Addendum No. 1
March 3, 2025

Project: Reroof Damaged Areas
South Dakota State University Student Union
Brookings, South Dakota
SDSU Project# 25-154440
OSE Project #R0325--12X/DEL
Architecture Incorporated Project #3099

Architect: Architecture Incorporated

ROOF SYSTEM #4:
EPDM MEMBRANE OVER 1/2" COVER BOARD OVER 2 1/2" TOP LAYER POLYISOCYANURATE OVER 1/4" PER FOOT SLOPE TAPERED POLYISOCYANURATE (OVERALL POLYISO STARTING THICKNESS 2 3/4") OVER VAPOR RETARDER.

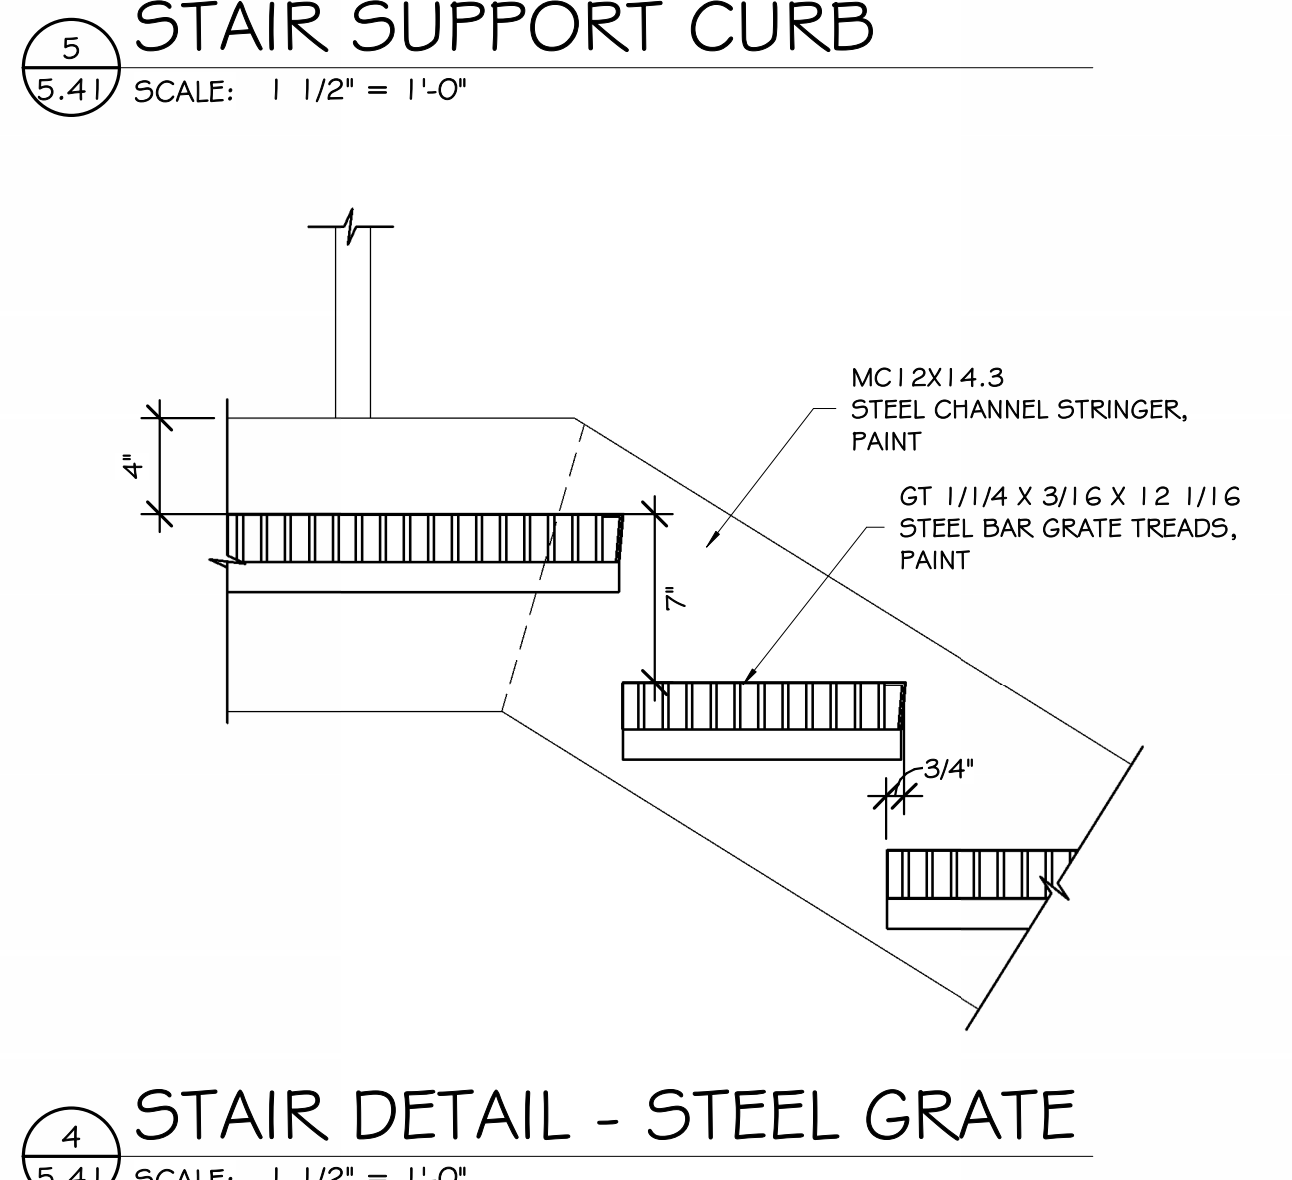
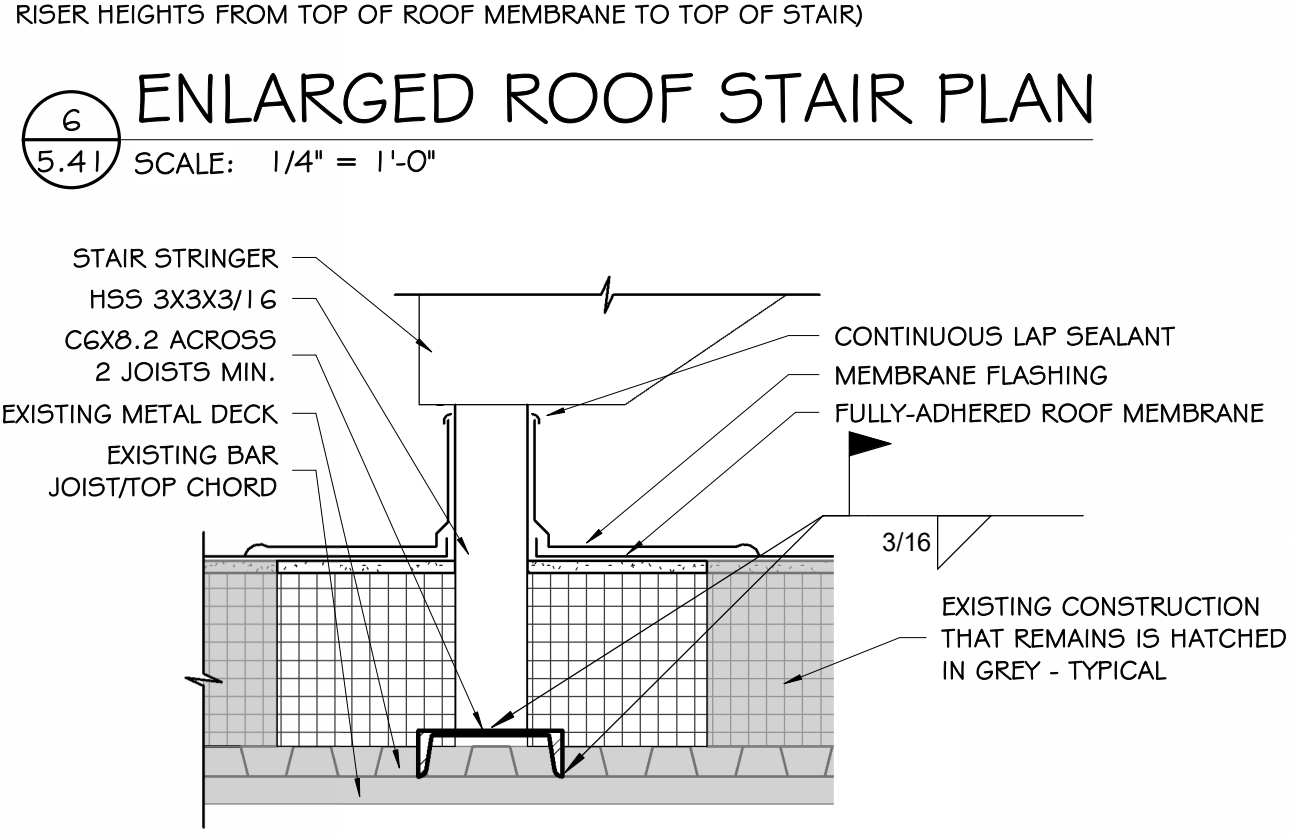
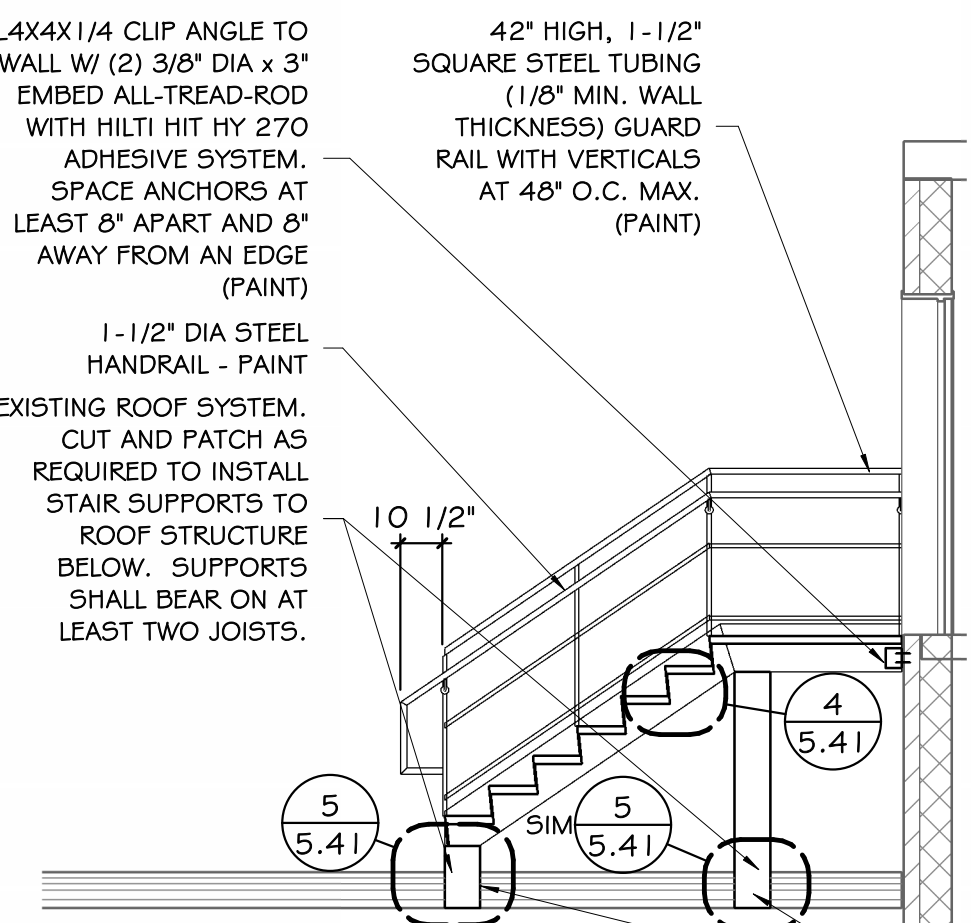
5) DRAWING SHEET 5.41 – ROOF PLAN

- a) Reference attached revised Drawing Sheet 5.41 for the following:
 - i) Base bid scope that has been changed to Alternate #2 and Alternate #3 scope.
 - ii) Added existing rooftop mechanical equipment at north side of the building.
 - iii) Added EPDM walkway pads around serviceable equipment, at the top & bottom of roof ladders/stairs, and at downspout discharge locations.
 - iv) Assumed locations of EIFS cutting & patching necessary to complete roof demolition and new construction.
